**Response to Submissions  
Marine Fuel Storage/Distribution  
and Biodiesel Production Facility  
Kooragang Island**

April 2008

**Prepared by**  
**Umwelt (Australia) Pty Limited**  
**on behalf of**  
**Manildra Park Pty Ltd**

FIGURE 4.2

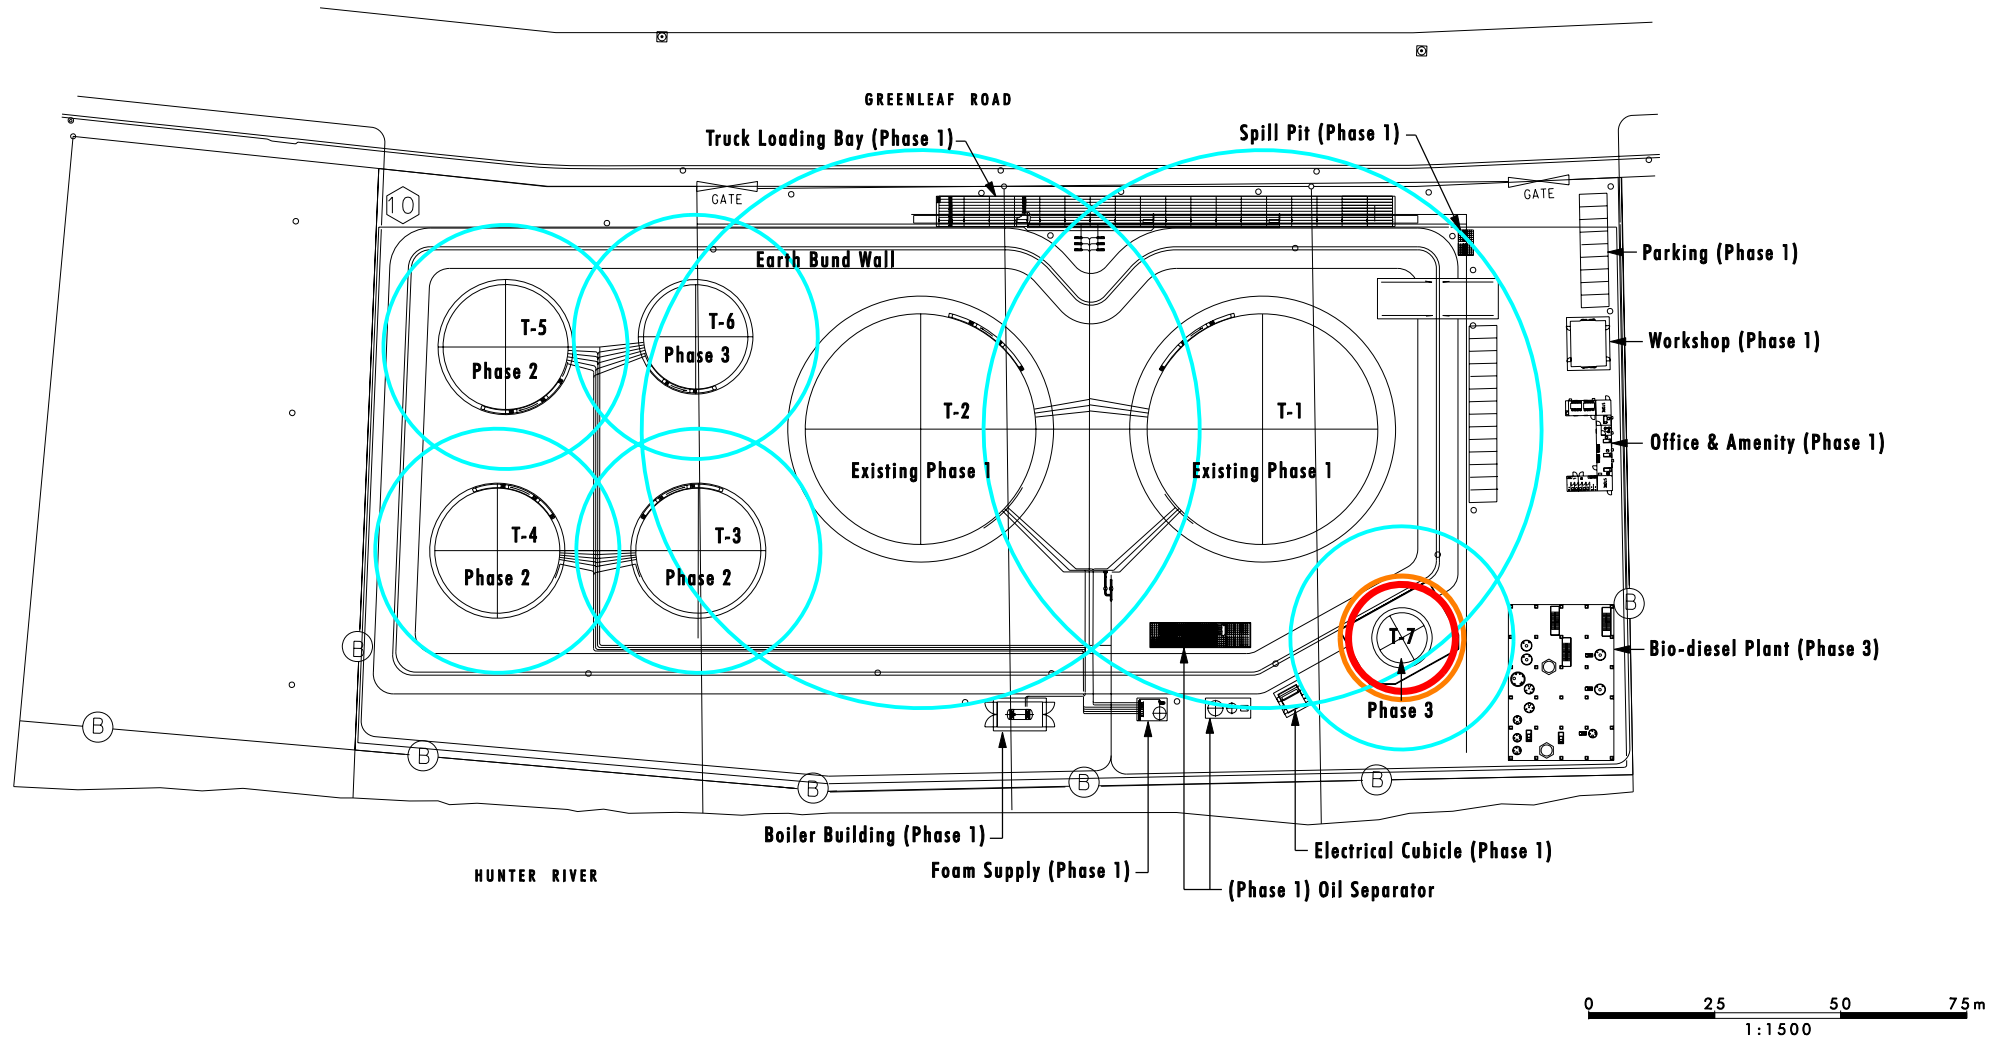
**Assessment of radiant heat from a tank/bund fire in the main tank farm on Orica's facilities.**

**Figure 4.2** shows the 23.0 kW/m<sup>2</sup>, 12.6 kW/m<sup>2</sup> and 4.7 kW/m<sup>2</sup> radiant heat contours for a methanol tank fire (T-7). The 23.0 kW/m<sup>2</sup> radiant heat contour does not extent to any structure either on or off site. It is therefore unlikely that a methanol tank fire would result in the propagation of an incident either on or off site.

**Figure 4.2** shows only the 4.7 kW/m<sup>2</sup> radiant heat contour for an oil/diesel tank fire, as the fire does not generate radiant heat levels in excess of approximately 7.32 kW/m<sup>2</sup>. Given the absence of a 23.0 kW/m<sup>2</sup> radiant heat contour for this scenario, it is unlikely that a oil/diesel tank fire would result in the propagation of an incident either on or off site.

**Figure 4.2** shows only the 4.7 kW/m<sup>2</sup> radiant heat contour for an oil/diesel tank fire, as the fire does not generate radiant heat levels in excess of approximately 5.19 kW/m<sup>2</sup>. Given the absence of a 23.0 kW/m<sup>2</sup> radiant heat contour for this scenario, it is unlikely that a oil/diesel tank fire would result in the propagation of an incident either on or off site.

During a fire incident the services of the NSW Fire Brigades may be required. The maximum radiant heat loads for each of the fire scenarios has been calculated. **Figures 4.2 and 4.3** show the 23 kW/m<sup>2</sup>, 12 kW/m<sup>2</sup> and 4.7 kW/m<sup>2</sup> thermal radiation contours around the tanks and bunds.

**FIGURE 7.2**  
**Transect A-A' Through**  
**Greenleaf Road Terminal**

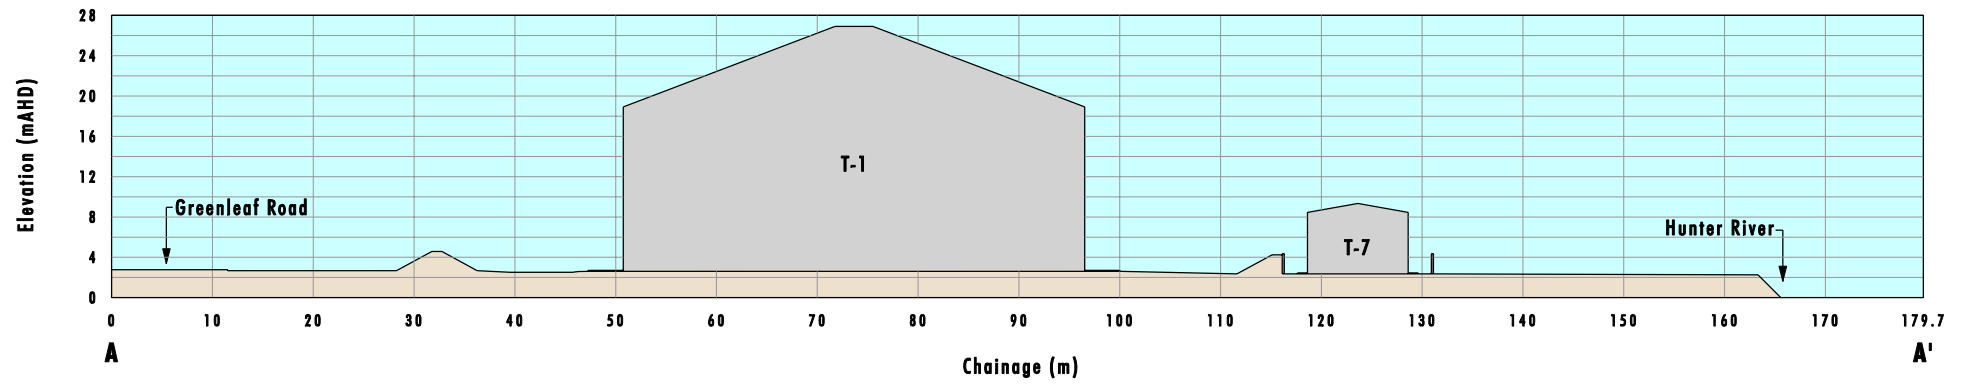
The Department of Planning Hazards Branch requested a cross sectional drawing of the facility.
